This is to certify that RREEF AMERICA REIT III C/P Z4/In has permission to TD Bank - Installation of New Storage to Include Six Stairs Total 2371" sqft AT 1 PORTLAND SQ CE 038 B001001

**City of Portland, Maine - Building or Use Permit Application**

**Proposed Project Description:**  
TD Bank- Installation of New Signage to Include Six Signs Totaling 237'1"sqft

**Site Survey and Recommendation**

**E02 North Elevation**

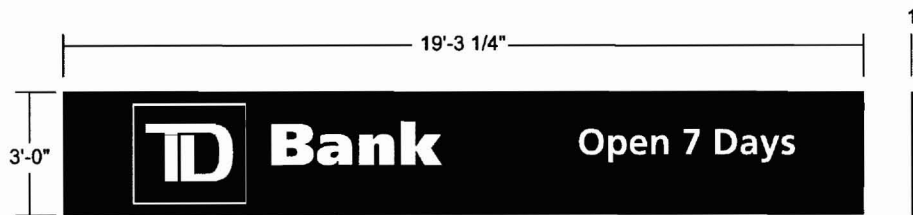
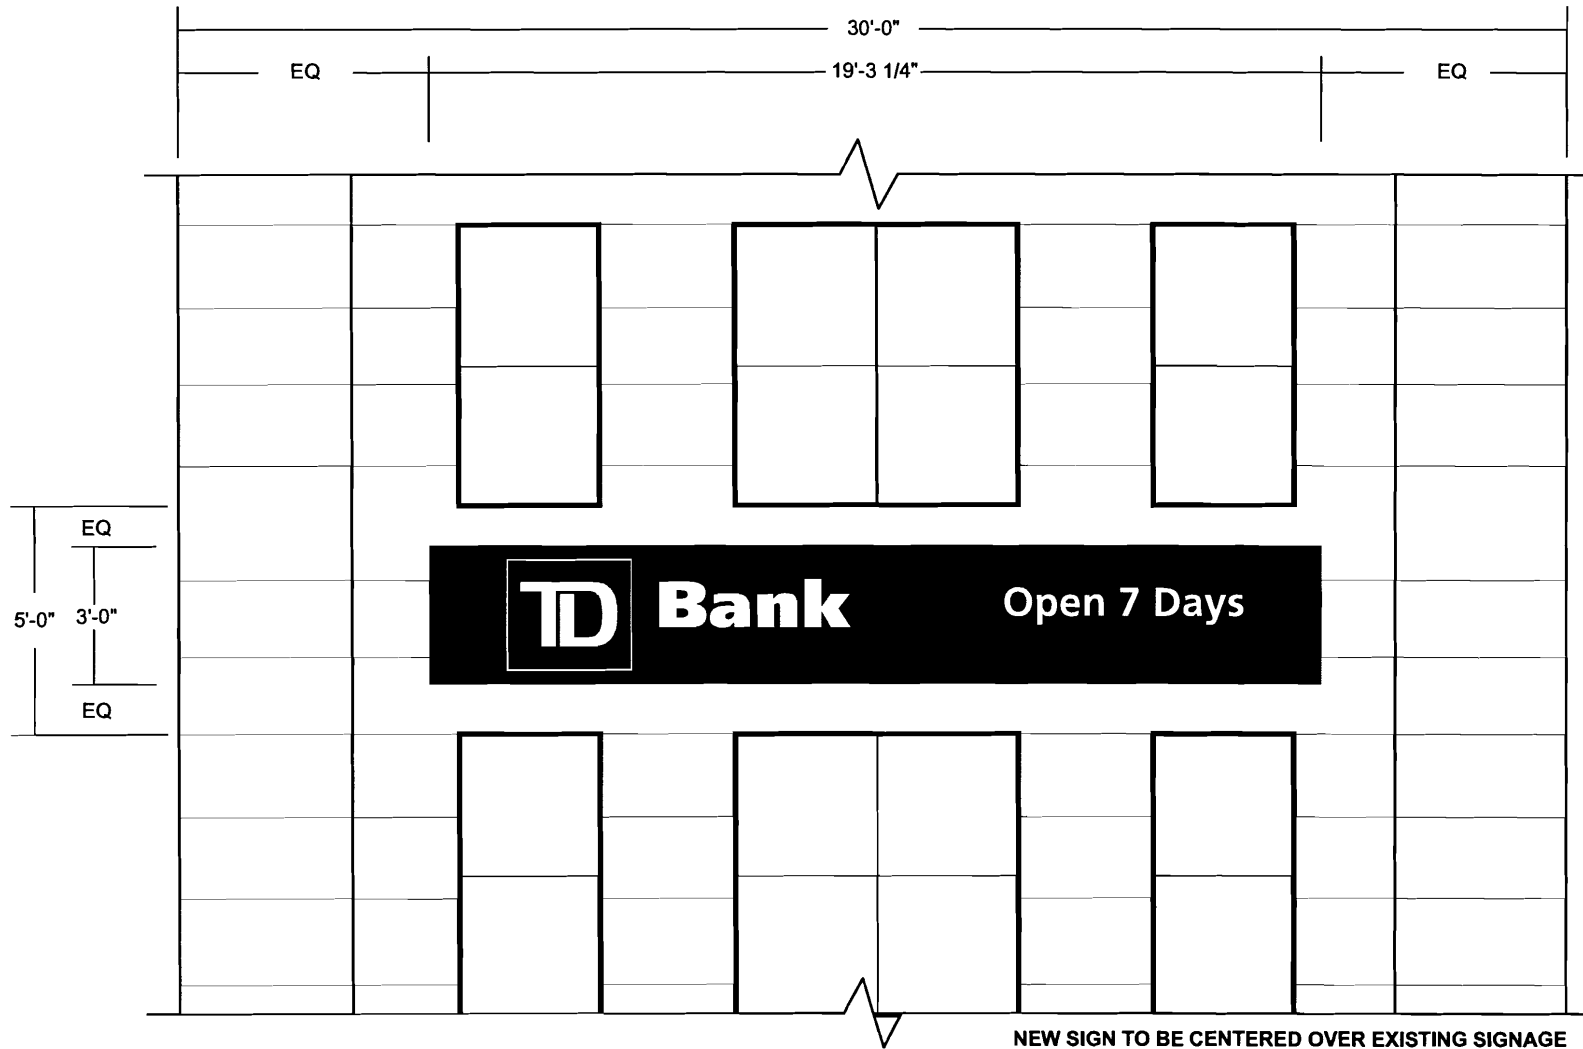
<b>Comments:</b>
3/3/2009-lmd: 02/17/2009 holding permit pending payment, 3/03/2009 received payment, sending permit to zoning.
3/5/2009-amachado: Left voicemail for Jason Prouse. Signs E02, E03, & E04 are all bigger than the existing ones. Need to know if tenant is just ground floor or upper floors too. If upper floor, need to know the square footage of the wall that the sign is located on. Sign E05 needs to be permitted. Need certificate of liability.
3/5/2009-amachado: Spoke to Jason. He will get me the wall area for the three signs. TD Bank does have offices above the ground floor.
3/26/2009-amachado: Received requested information,

E-2 vgar bar front sign - 5% of 12540 = 627<sup>th</sup>  
sign size = 57.81<sup>ok</sup>

E02: wall square footage is approximately 12,540 sq ft       $90 \times 50 = 4500$      $5\% = 225$      $4500 + 225 = 4725$   
E03: wall square footage is approximately 6,650 sq ft  
E04: wall square footage is approximately 6,650 sq ft

**E03 South East Elevation**

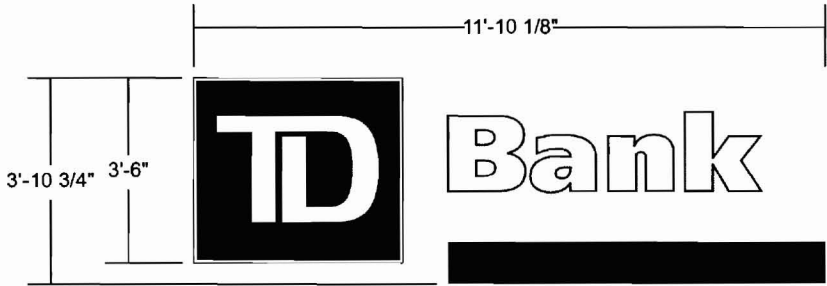
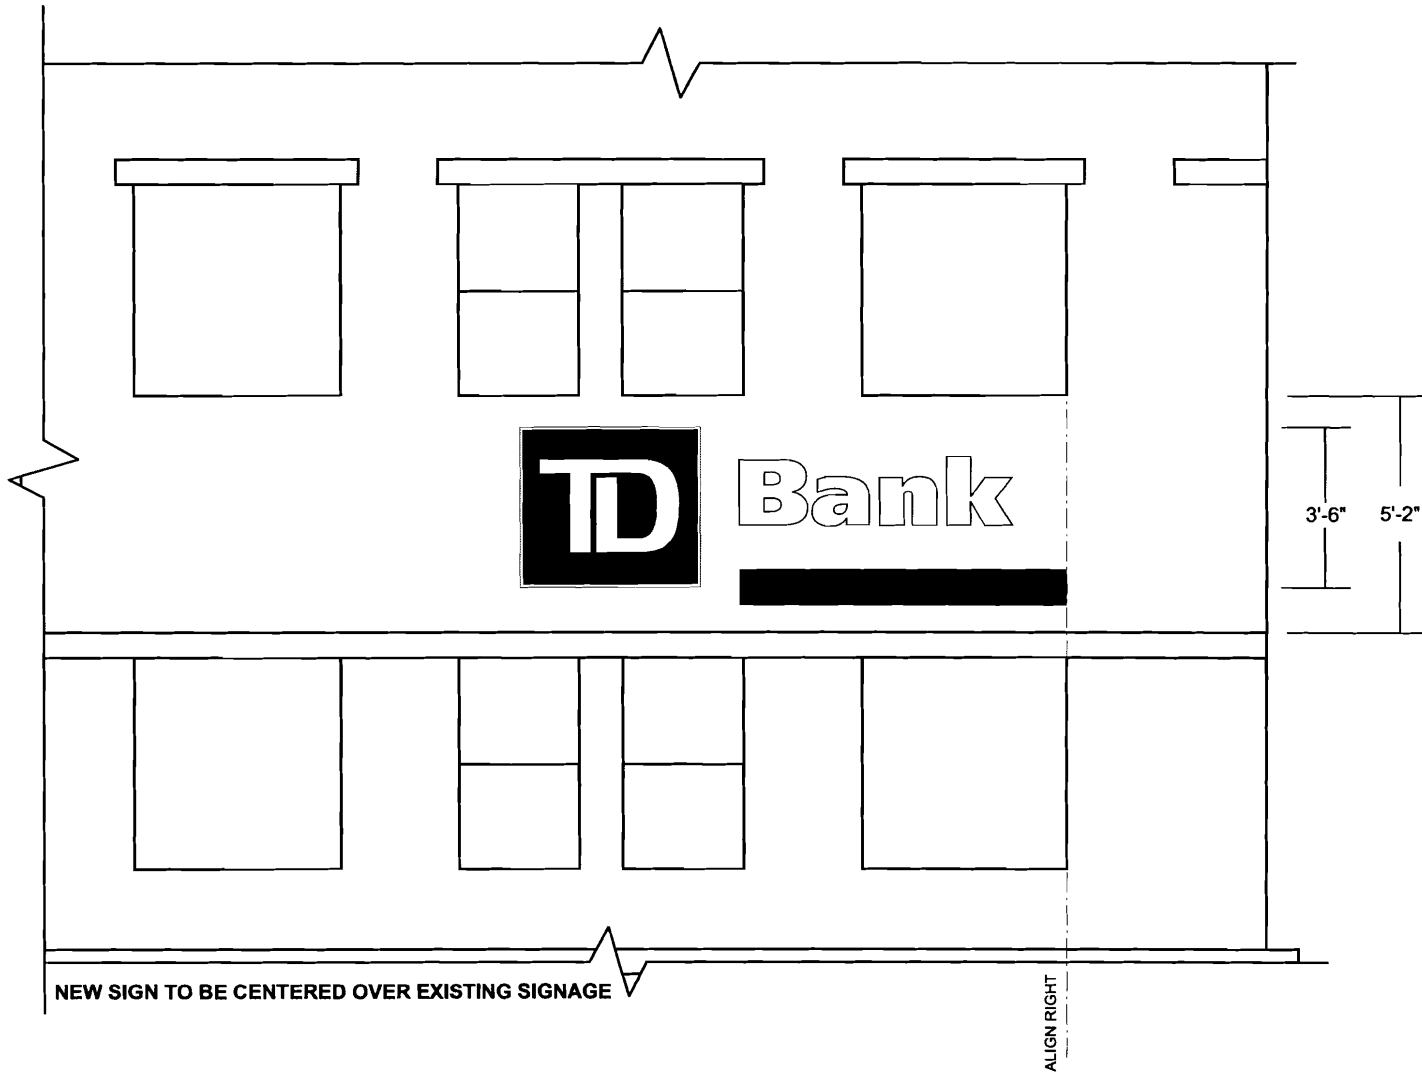
E-3 5% of 6650 = 332.5<sup>th</sup> - sign is 46.14<sup>ok</sup>

**E04 South West Elevation**

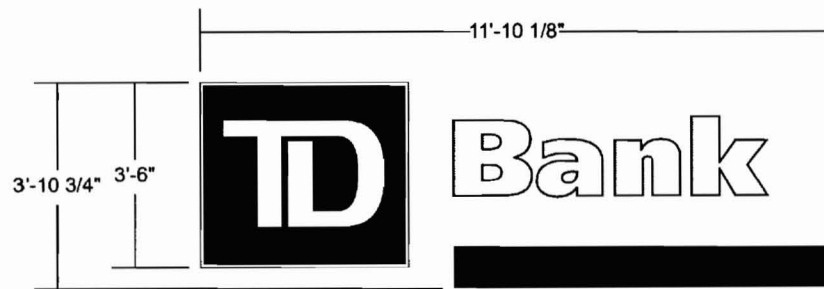
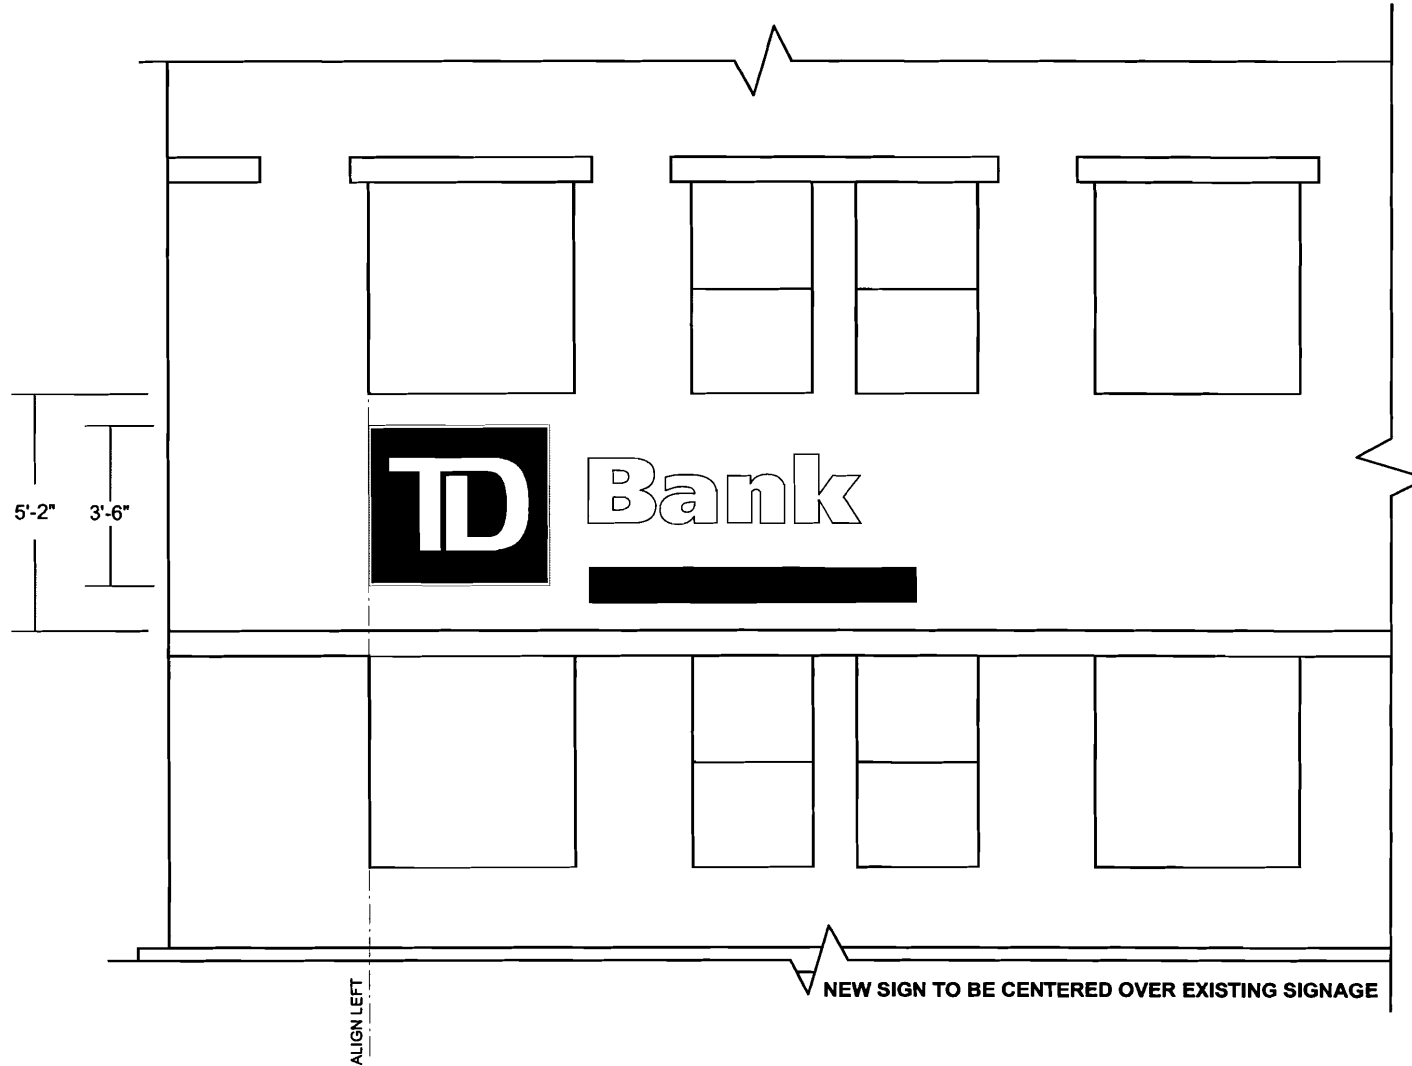
E-4 5% of 33660 = 332.5<sup>th</sup>  
signs 46.14<sup>ok</sup>
